SUBJECT: Forwards info supplementing 841004 & 1101 ltrns providing
 addl info re SPDS implementation plan & parameter selection
 repts per 840815 & 0914 requests.

Re: Turkey Point Units 3 & 4
Docket Nos. 50-250 & 50-251
St. Lucie Units 1 & 2
Docket Nos. 50-335 & 50-389
SPDS Implementation Plan and
Parameter Selection Report

RESPONSE TO NRC QUESTIONS

FIGURE 1

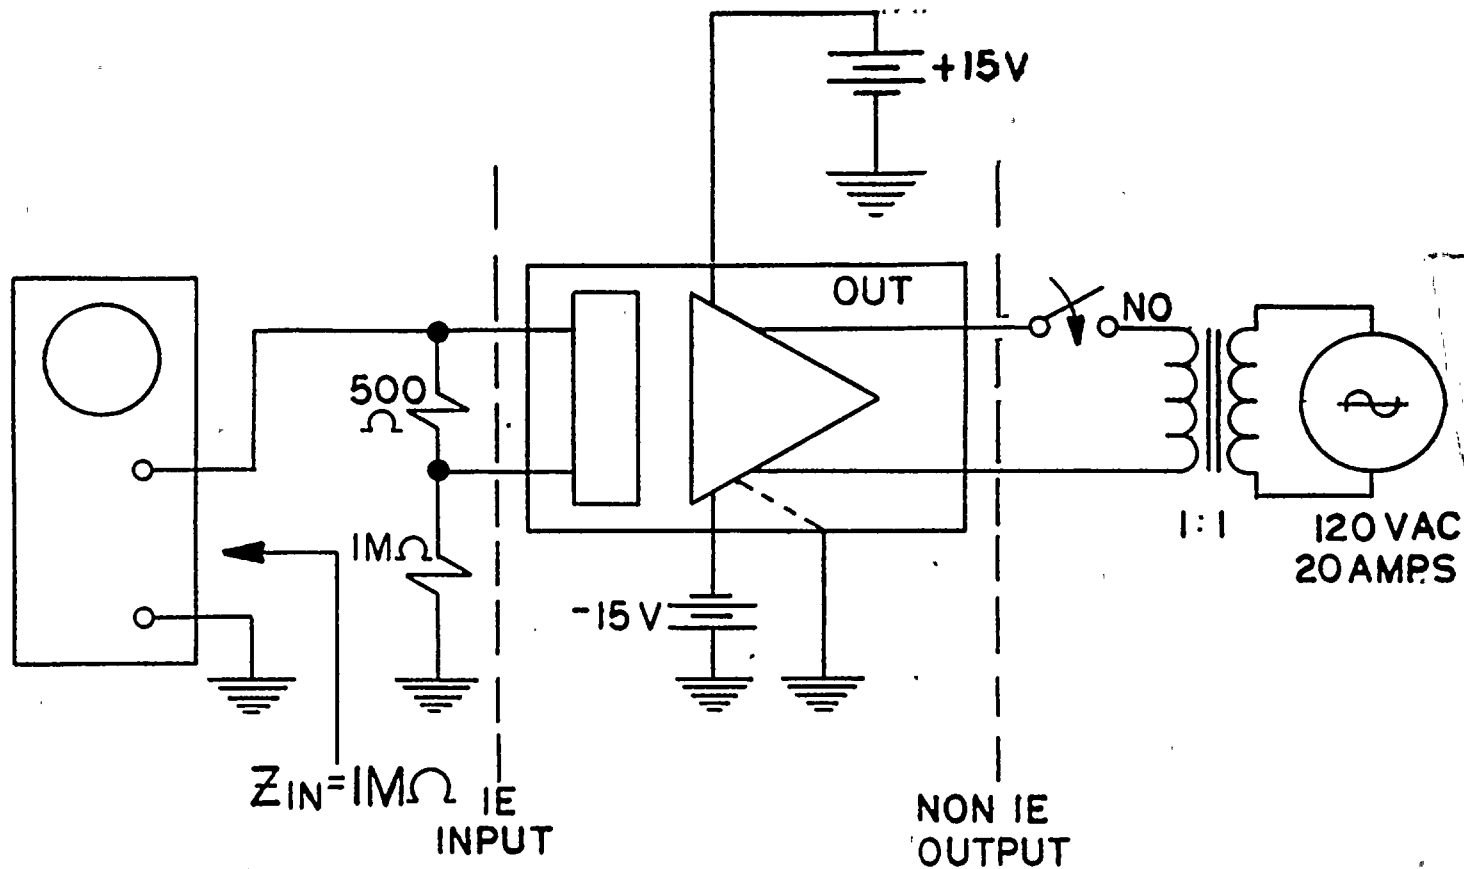
During review of the Safety Parameter Display System (SPDS) Implementation Plan and Parameter Selection Report for both St. Lucie and Turkey Point Plants, the NRC reviewer raised several questions on the choice of maximum credible fault applied to the isolators for the SPDS. In a telephone conversation between FPL and NRC on November 15, 1984, FPL agreed to test the isolators at 120 VAC in the transverse mode at a current of 20 amperes.

As shown by Figure 1, 120 VAC was applied in the transverse mode across the non IE outputs of the Model 156, 980 and 981 isolator modules. At the same time, an oscilloscope was used to monitor the class IE inputs of the isolator for any transients caused by the fault applied and to observe the steady state condition of the IE input side of the isolators during the fault. The fault was applied to each of the modules for a minimum of 20 seconds to ensure adequate time for any failure to propagate and to allow sufficient time to observe the steady state condition of the IE inputs. The test results are given below:

MODEL 156

There were three pulses approximately four microseconds in width and with an amplitude of 0.3 Volts within the first 35 μ s of applying the fault. No other perturbations were observed.

MODEL 980

The transient condition was a single pulse of 12 μ s duration and 0.2 Vpk.-pk. No other perturbations were observed.

MODEL 981

A 1.6 Vpk-pk, 8 μ s. pulse occurred at the application of the 120 Vac then a 0.3 Vpk-pk 6 μ s pulse occurred 100 μ s later and finally a 0.1 Vpk-pk 4 μ s pulse occurred 20 μ s later. No other perturbations were observed.

FPL has reviewed the results of the test and determined that no components on the IE input side of the isolators would be damaged or stressed should a fault ever occur during plant operation. The integrity of the isolation boundary has been maintained.

The fault voltage observed on the IE side was small compared to the normal signal voltage for an instrument loop (Typically 24 volts) and was of a short duration such that no effect would be expected. After the initial transient condition, no effect was observed on the IE side. FPL concludes that the integrity of the isolation boundary would be maintained should a maximum credible fault occur during system operation.
